MONTGOMERY COUNTY HISTORIC PRESERVATION COMMISSION STAFF REPORT

Address: 7006 Carroll Ave., Takoma Park Meeting Date: 10/9/2024

Case No.: 1077218 Staff: Laura DiPasquale

Proposal: Install signage

Structural frame for signage

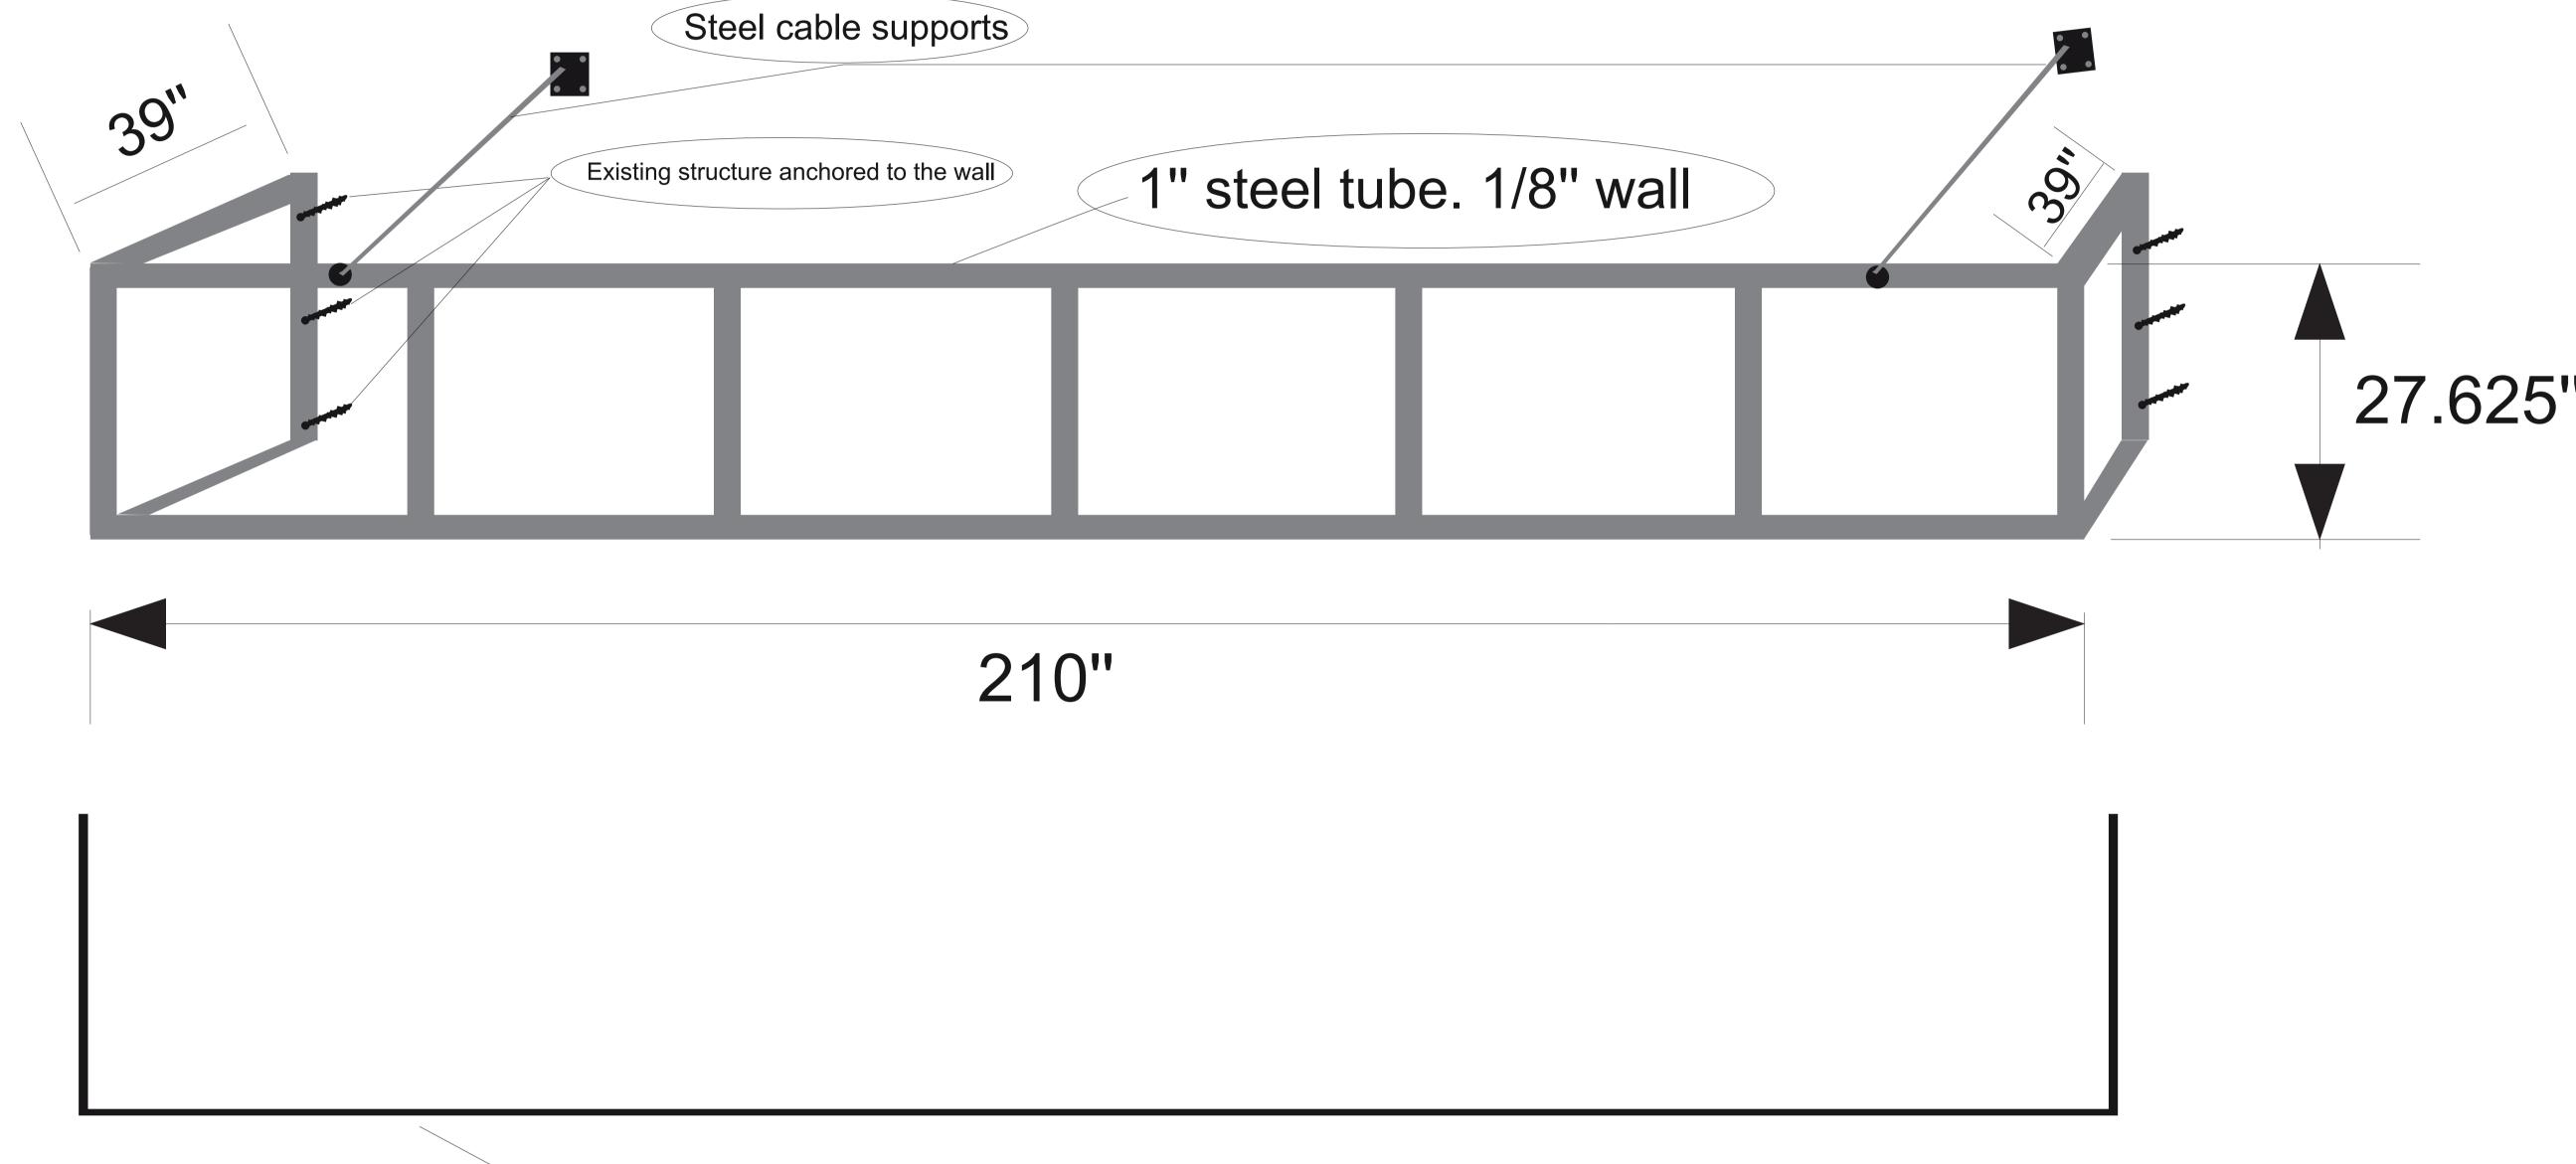
1. The steel cable frame supports must be installed so as not to be visible from the street, or installed so that they are evenly spaced and attach into the mortar joints between the bricks. The cable frame supports must not overlap or cover the recessed band above the awning.

1. The steel cable frame supports must be installed so as not to be visible from the street, or installed so that they are evenly spaced and attach into the mortar joints between the bricks. The cable frame supports must not overlap or cover the recessed band above the awning.

Top view of sign face

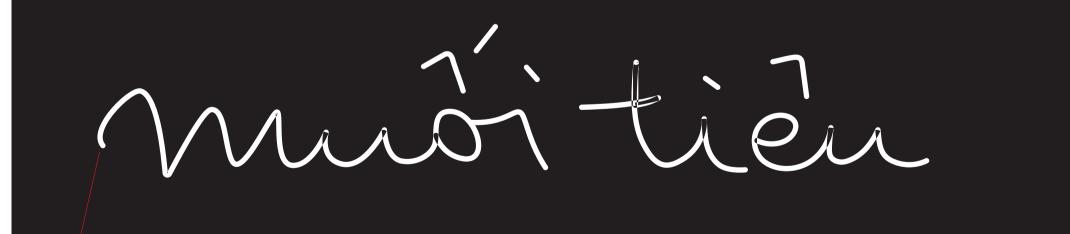
The *Design Guidelines* state that signs may be a maximum of 30 inches high and project not more than eight inches from the outside façade of the exterior wall, and that individually lit letters are permitted. Staff finds that the proposed signage would include individually-lit neon letters between 10 and 17 inches tall by 92 inches wide and 2 inches deep, complying with the *Design Guidelines*.
